Lafayette County Development Services
Planning, Zoning & Building Inspection

To: Lafayette County Planning Commission
From: Tristan Riddell, Planner
Meeting Date: September 28, 2026
Case: 26-315

Re: The Greens at Taylor Subdivision, Phases 1 - 4
Plan Review Comments Response

Below is a summary of responses (in red) to Land Development Review Committee comments for the captioned project.

REVISIONS:
DATE: 09/08/2026
DRAWN BY: JDC
SHEET NO. 4A

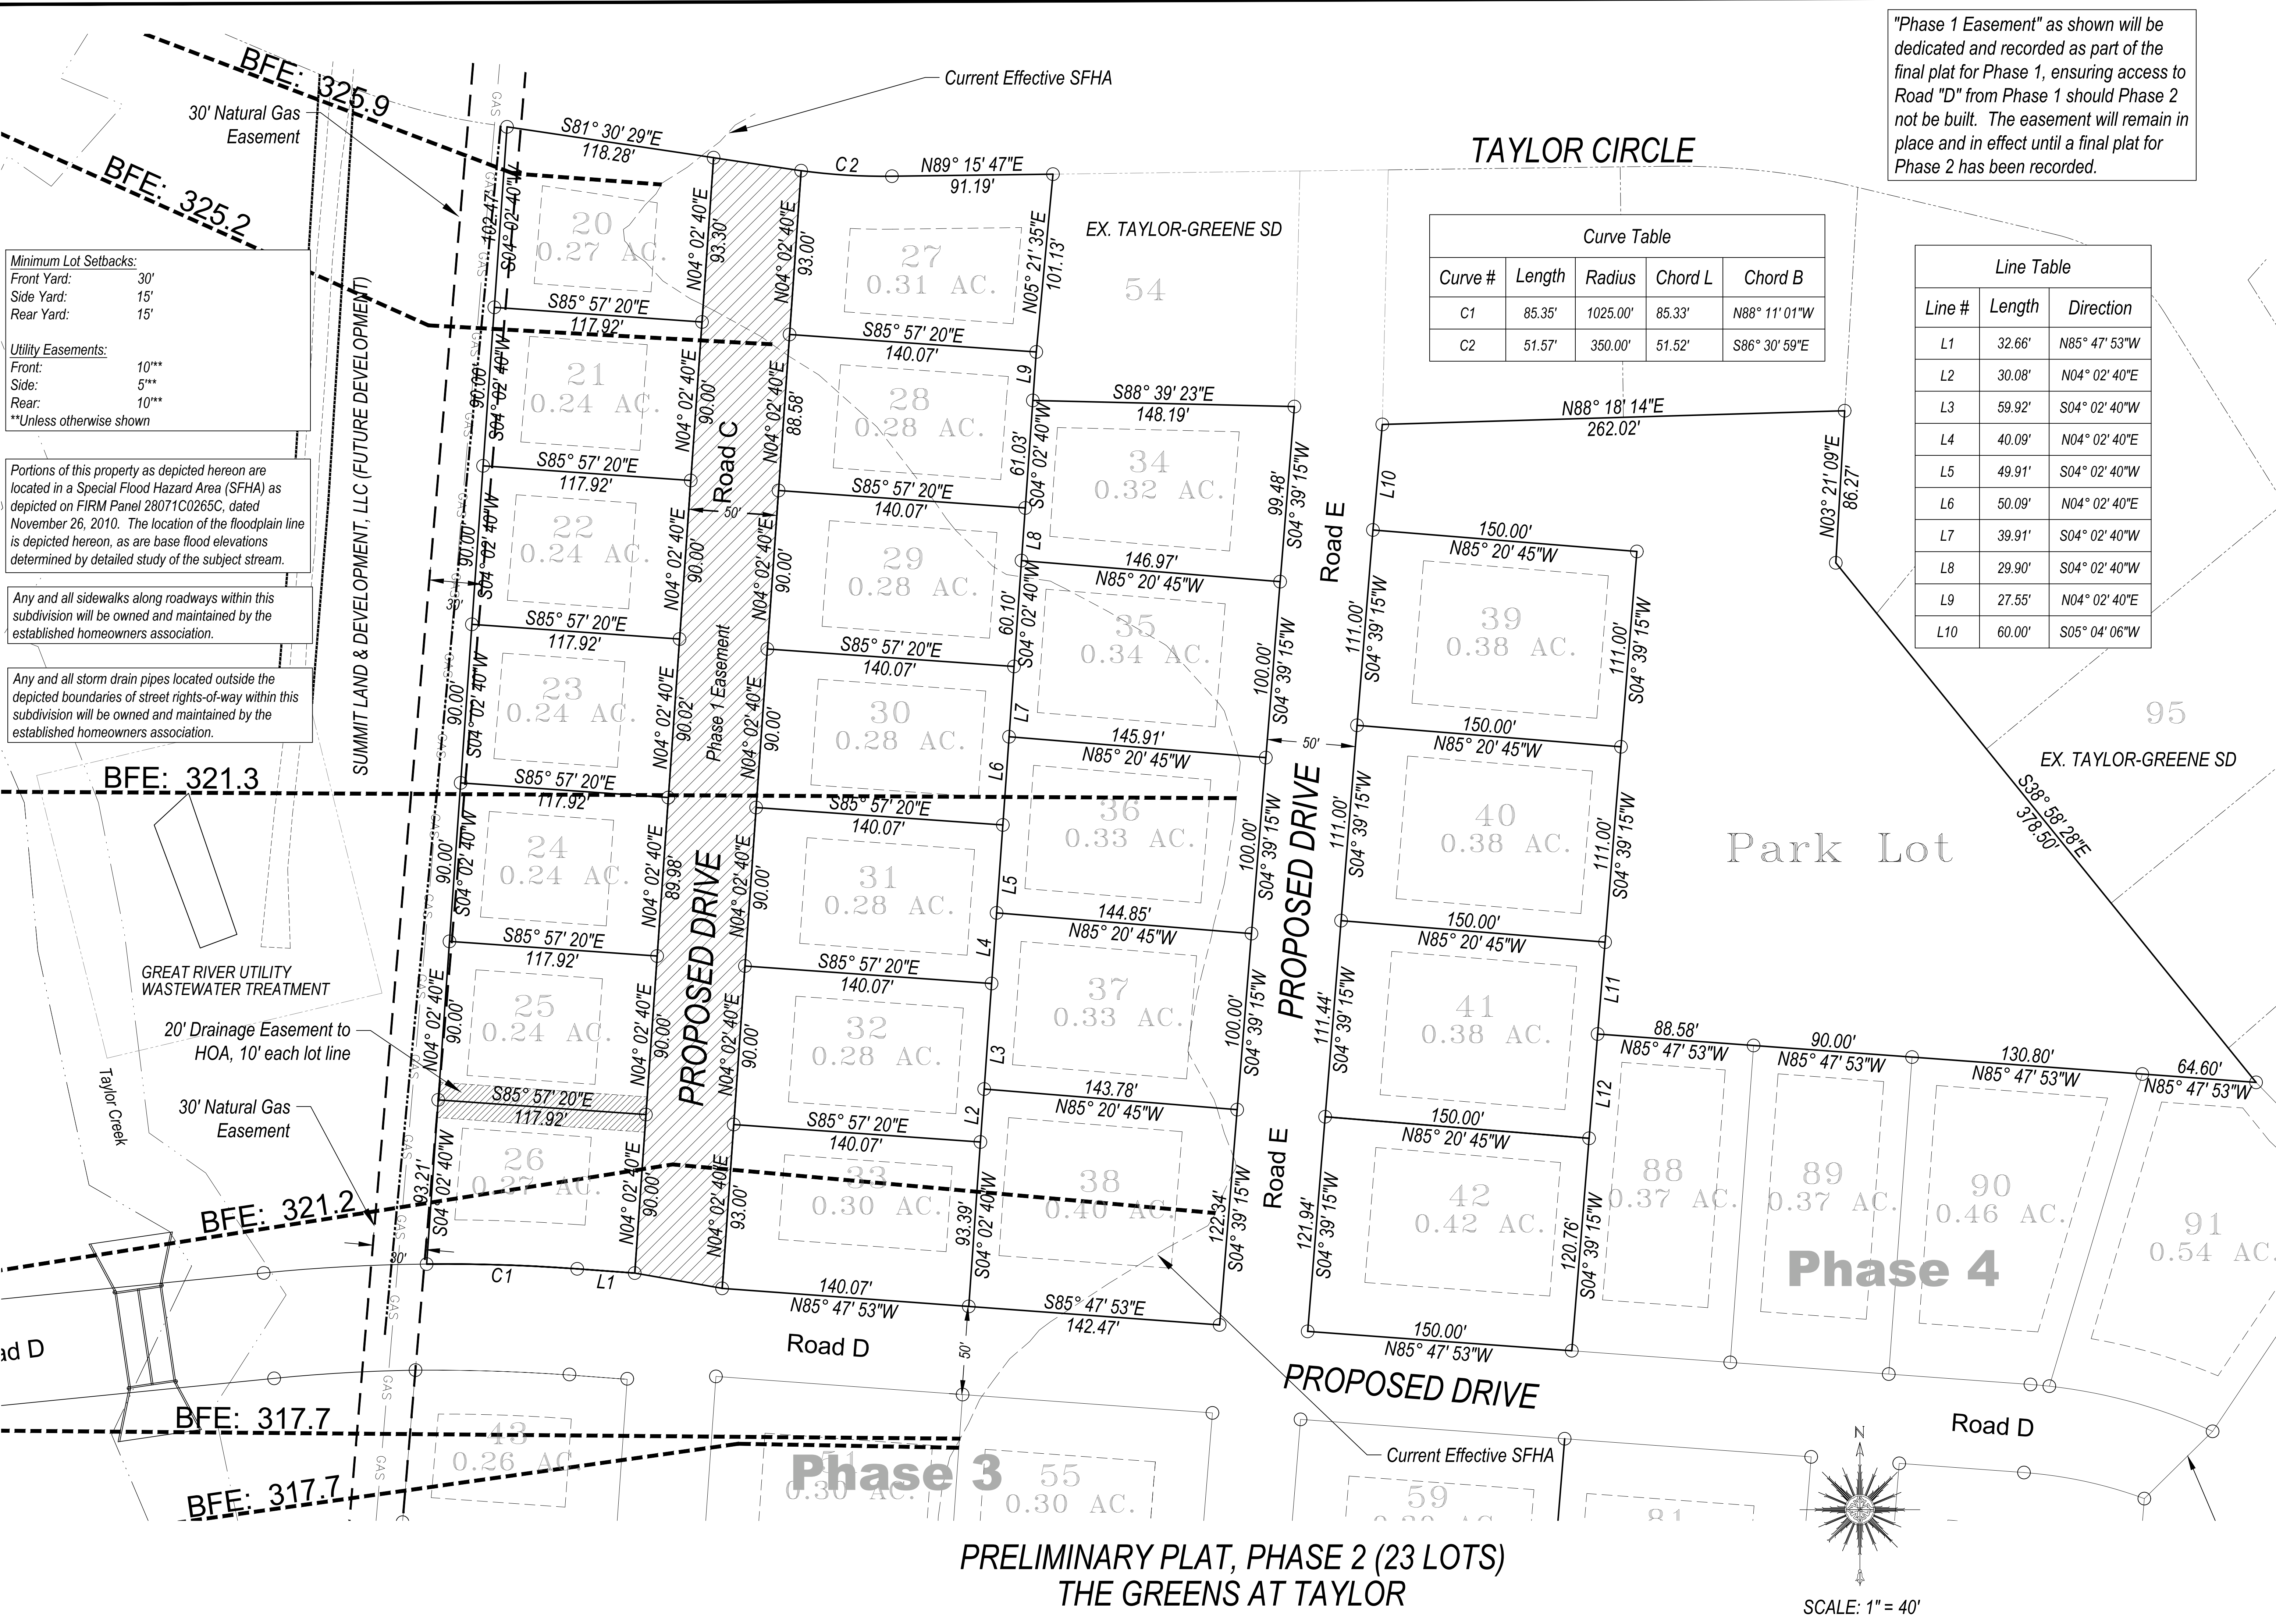
6. An easement needs to be attached and shown to Phase 1 allowing access to Road D and language for it to be built (included in Phase 1 bond) and dedicated to the county if other phases are not constructed within 12 months of the 1st building permit being issued in Phase 1. **Done, added as sheet 4A**

"Phase 1 Easement" as shown will be dedicated and recorded as part of the final plat for Phase 1, ensuring access to Road "D" from Phase 1 should Phase 2 not be built. The easement will remain in place and in effect until a final plat for Phase 2 has been recorded.

THE GREENS AT TAYLOR
PHASES 1-4 STORM DRAIN LAYOUT
LAFAYETTE COUNTY, MISSISSIPPI

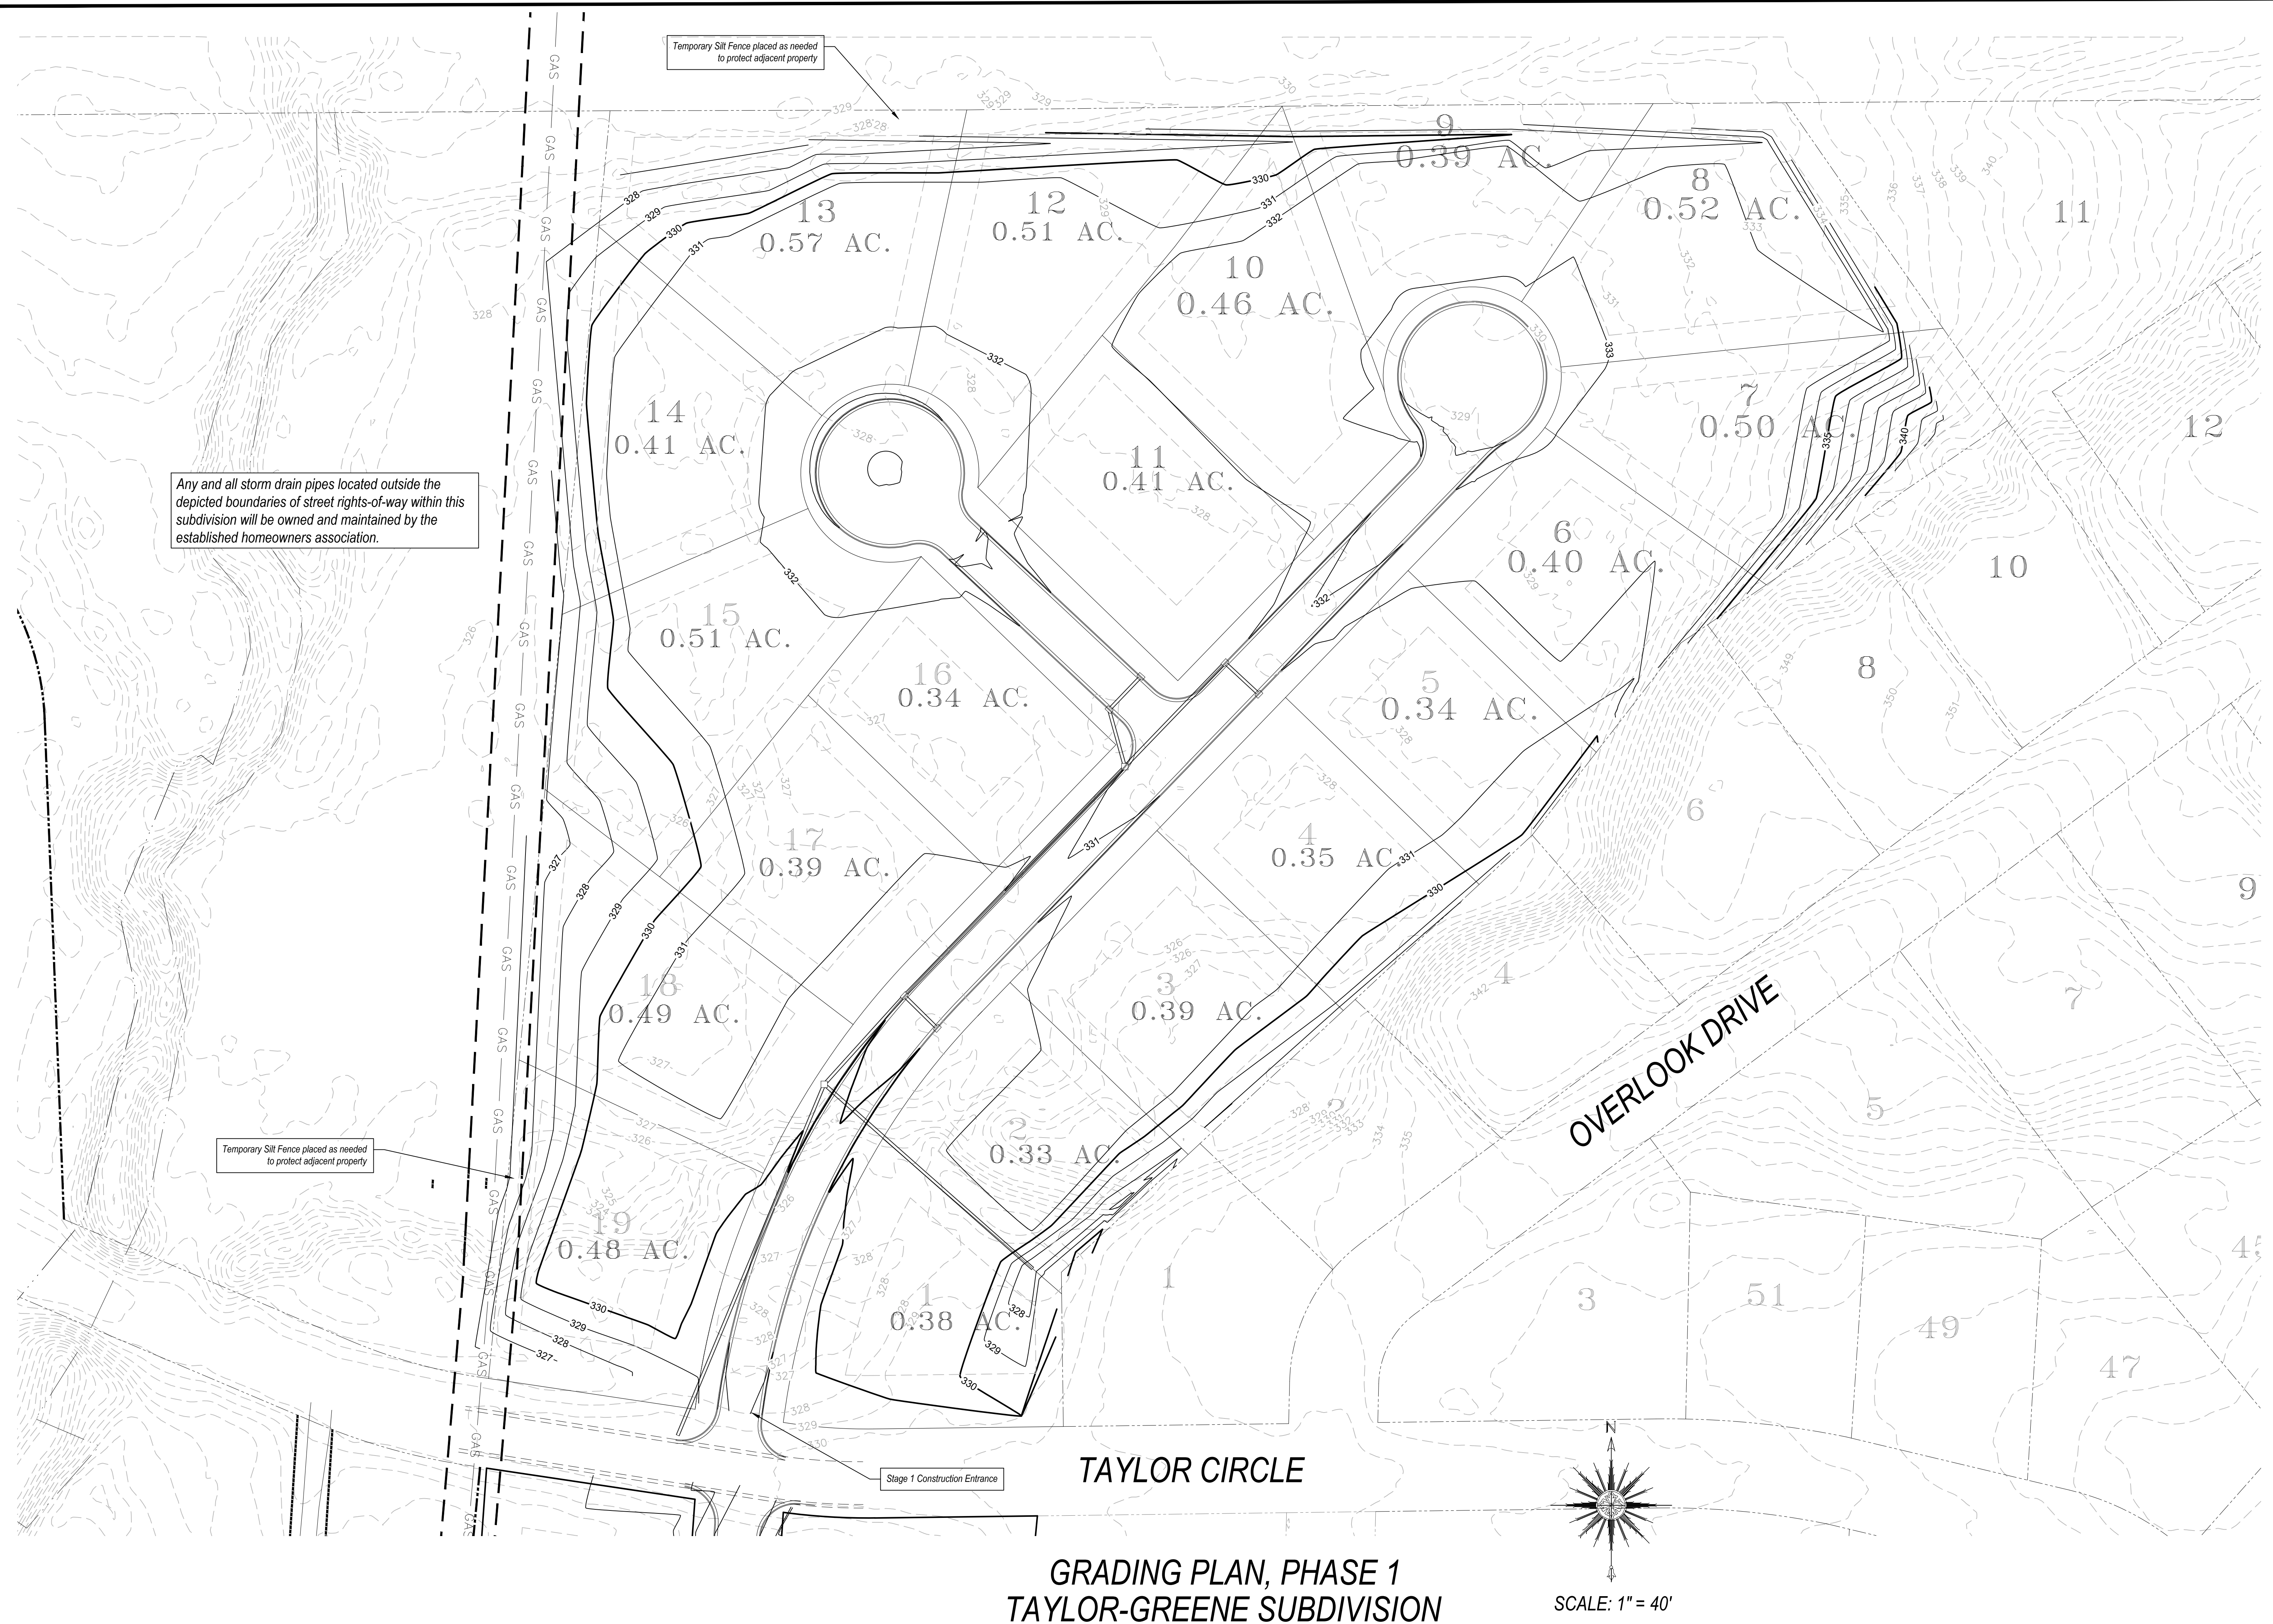
7. All inlets are to be installed at the same slope as the curb, do not install where it creates "flat spots in the curb." **Noted**
8. Make JB-1 a curb inlet, as designed top will not work with the curb. **The junction box lid will be constructed below grade at this location. There should be no conflict with curb**

9. Make JB-4 a curb inlet, as designed top will not work with the curb. **See above**
10. Inlet between lots 50 and 58 needs to be a double wing inlet due to being in sag points with no other way for water to escape. **Done**
